**Planning Board Meeting Agenda
Brunswick Town Hall
85 Union Street – Council Chambers
Tuesday, February 10, 2026 @ 6:00 PM**

DRAFT FINDINGS OF FACT SITE PLAN AMENDMENT PLANNING BOARD

MAINEHEALTH
MID COAST CANCER CENTER RENOVATION
81 Medical Center Drive
Brunswick, ME 04011

3 LINAC NORTH
A4.01 3/16" = 1'-0"

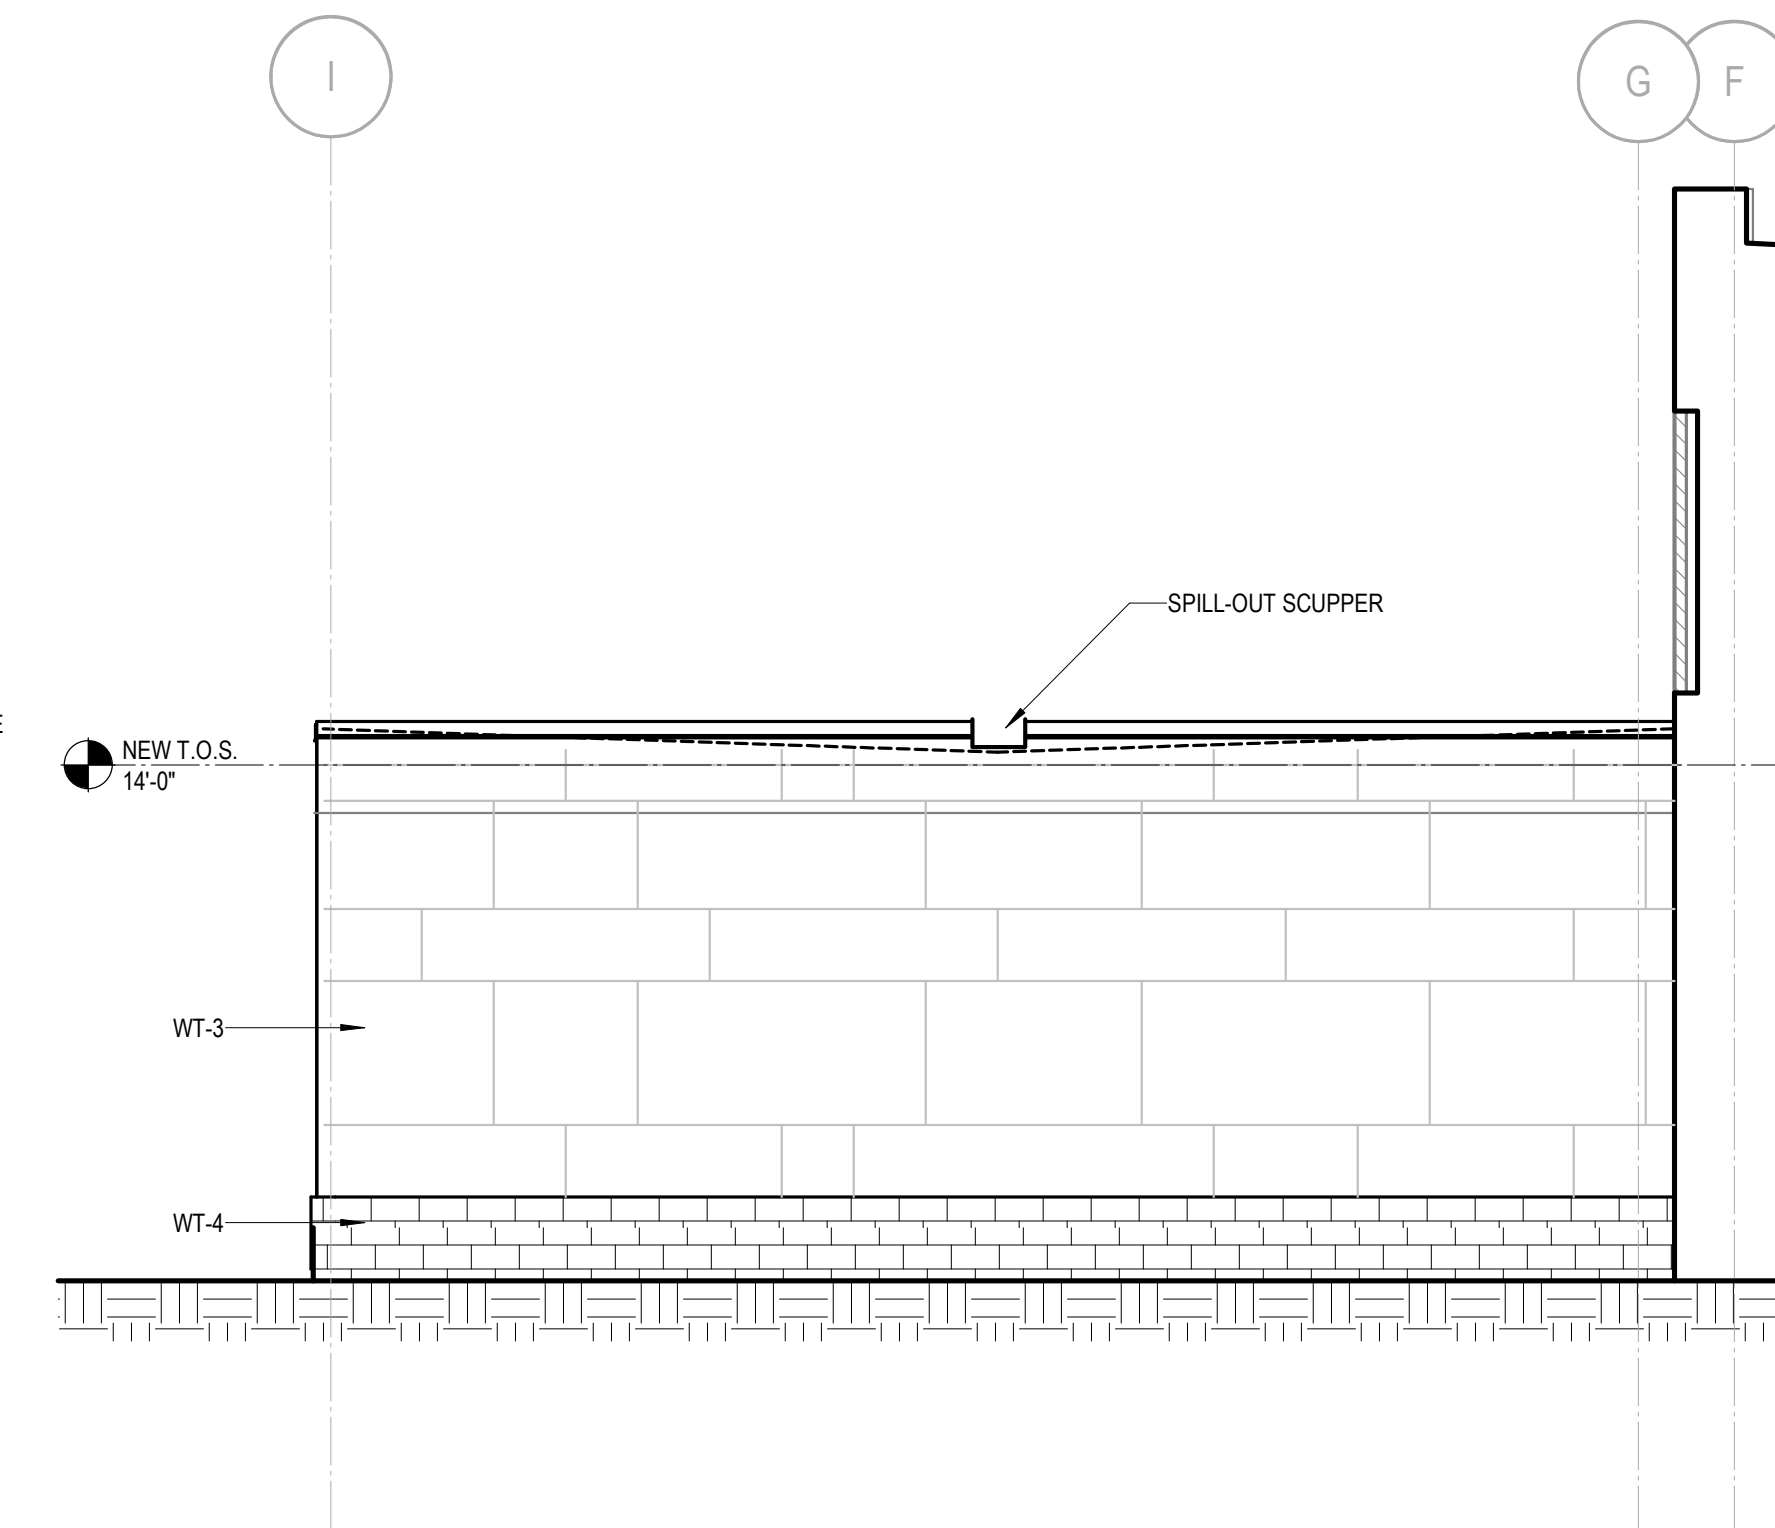
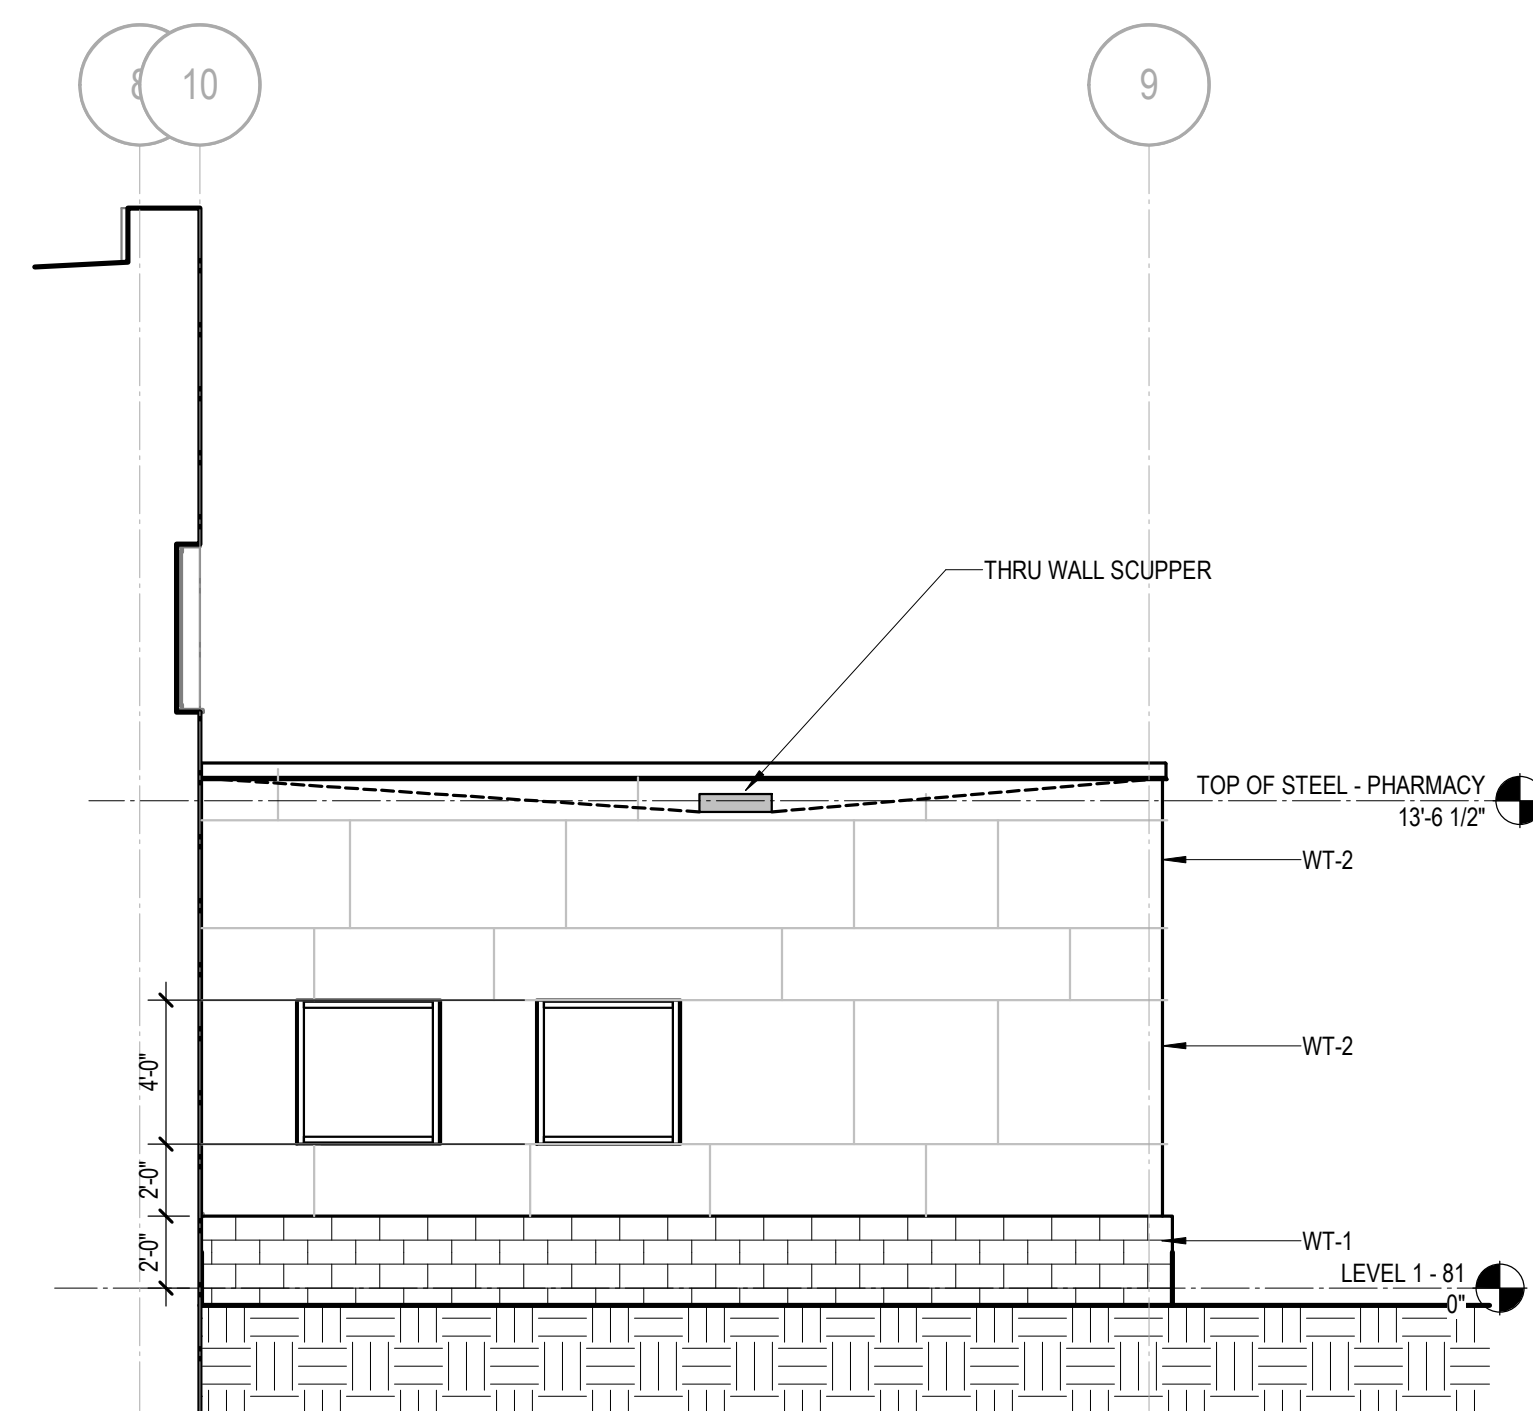
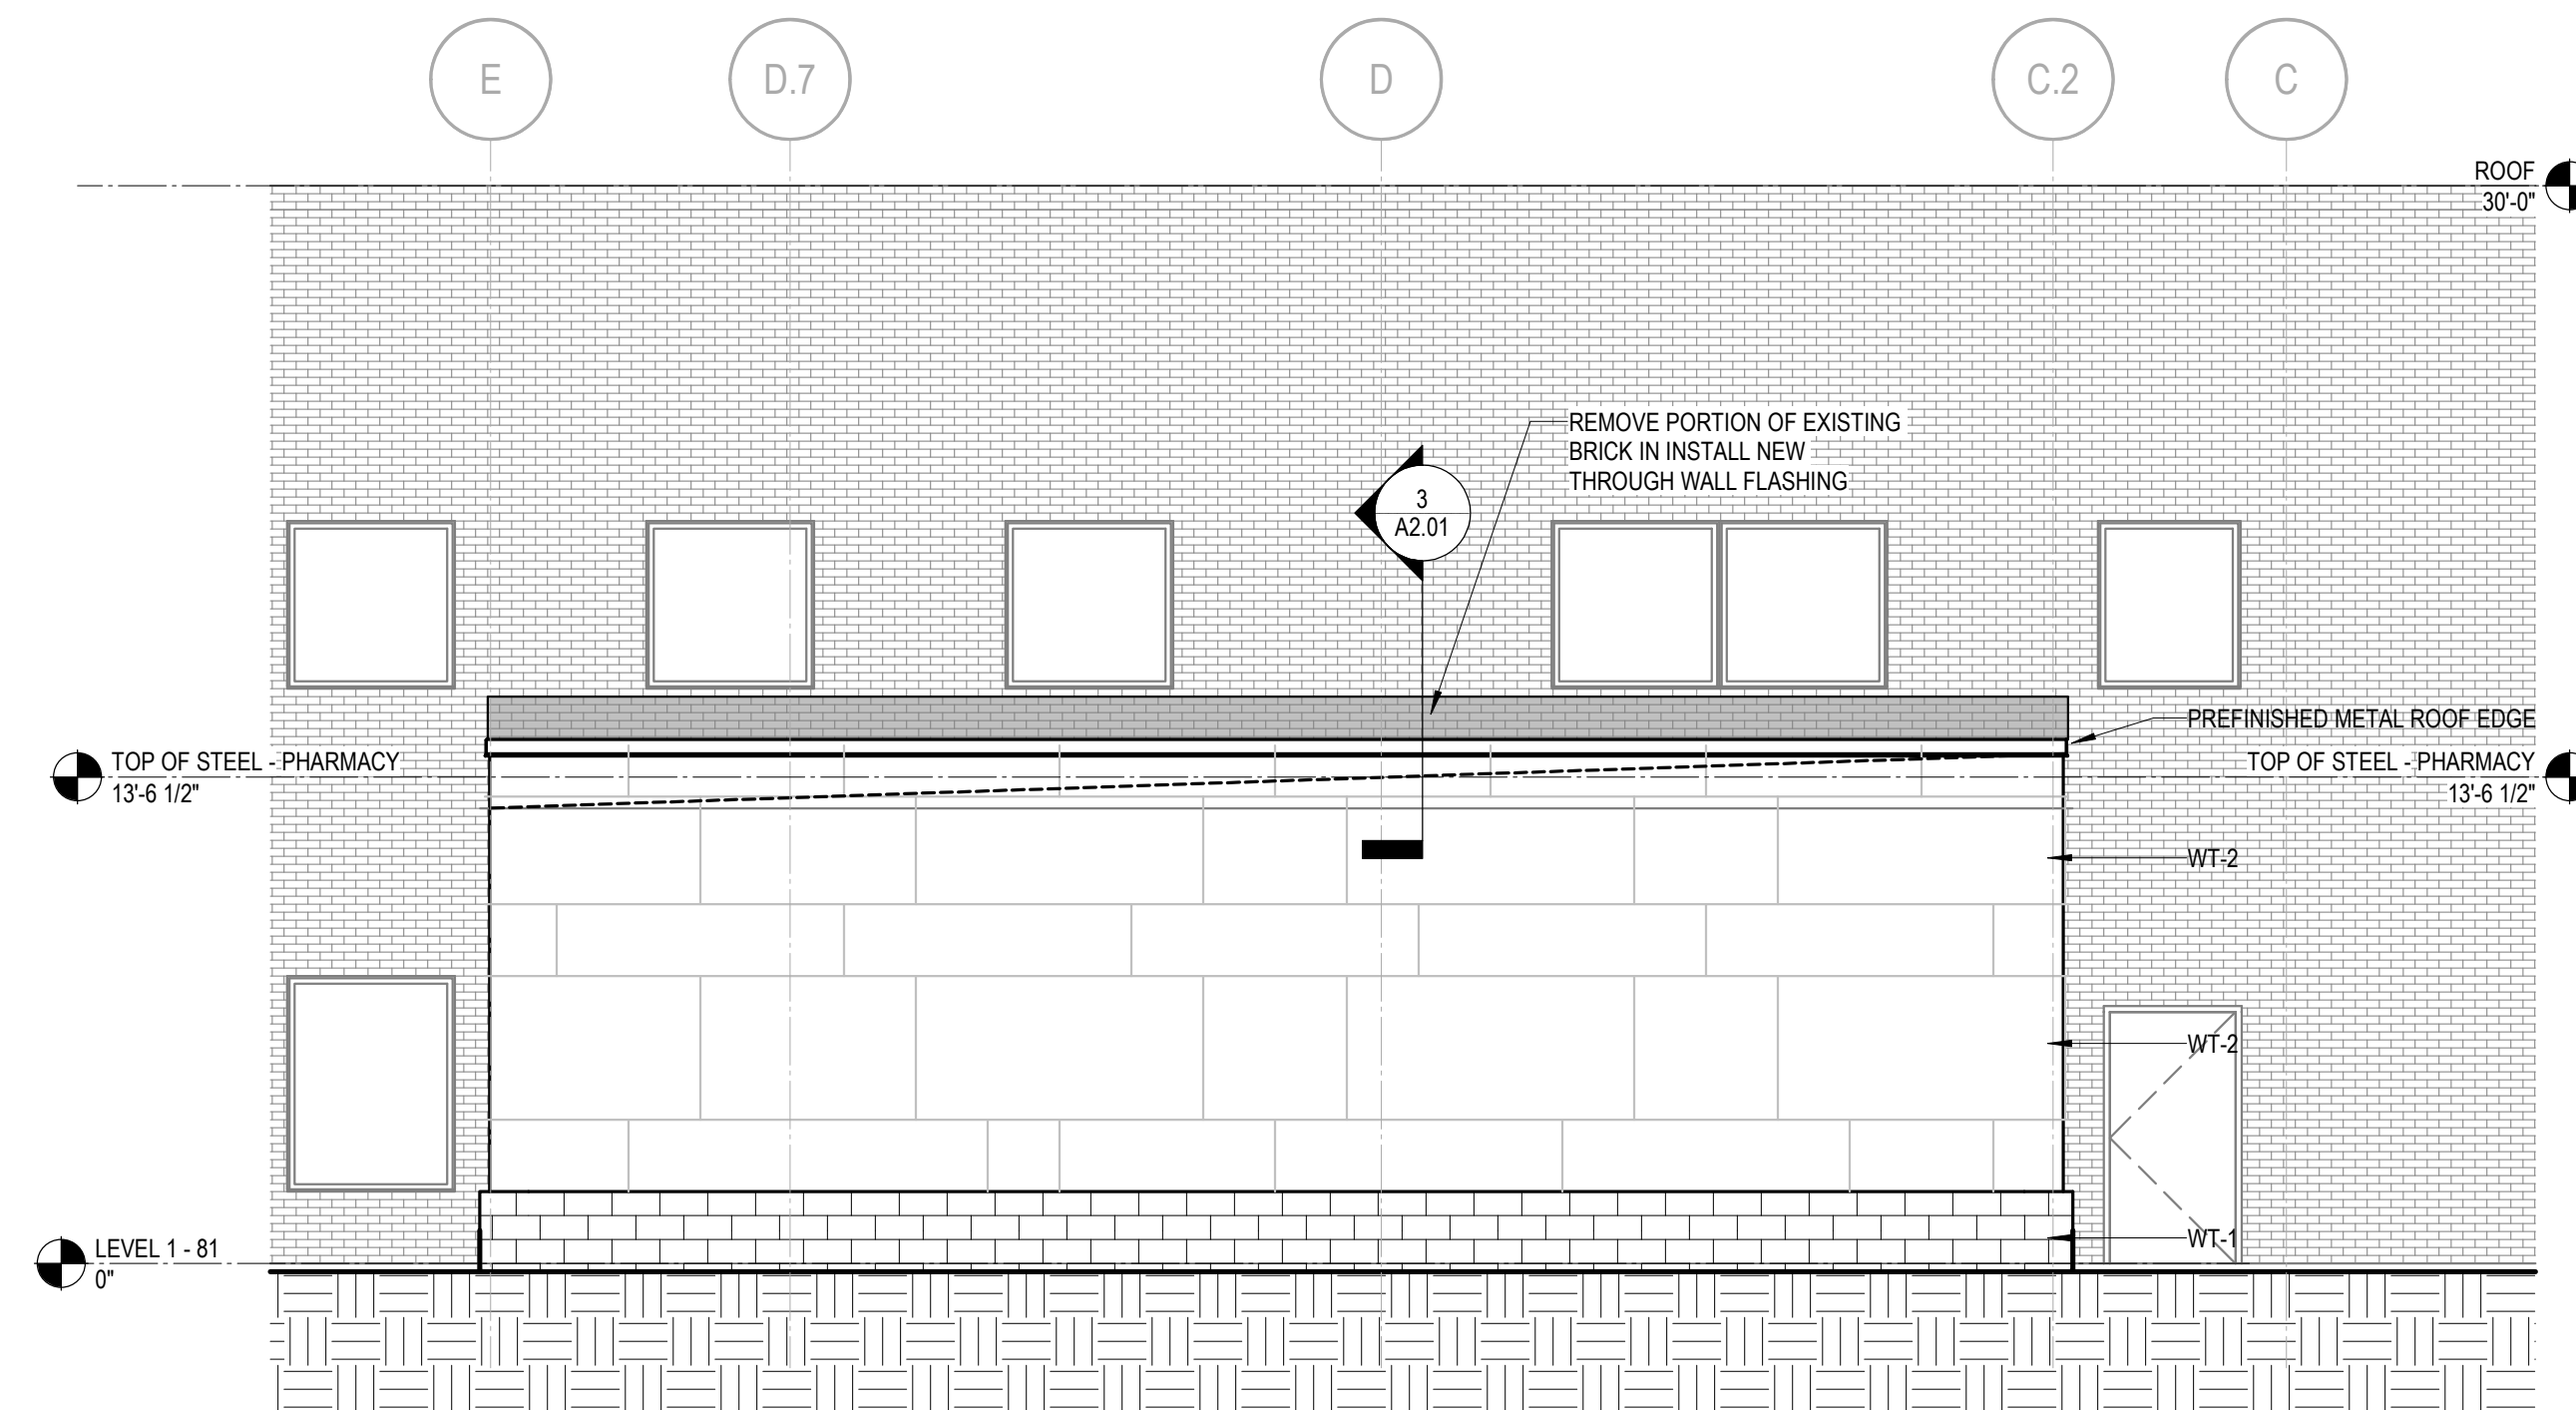
3.4 J Windowless circumstances says, "buildings without windows, i.e. a computer, a server building or self-storage buildings, shall incorporate a change in scale and siding materials instead of windows to create a sense of rhythm and cadence to create human scale. These material scale changes shall be demonstrably compatible with the scale and cadence of adjacent building facade treatments". The LINAC part of the building is towards the back, but the pharmacy faces a parking lot, so that is a little bit human facing.

3. Add ornamental grass along parking lot side of pharmacy, near bollards	See Section B-B on AS3.00 Civil Details
Architecture Comments	
4. Review Cooks Corner Design Standards, specifically Section 3.4 Façade Requirements, and within 3.4.j.	See Exhibit 8: Cook's Corner Design Standards Narrative.
Engineering Comments

The two additions to 81 medical center drive are secondary facades according to the definition in Section 3.4 Façade Requirements item C.
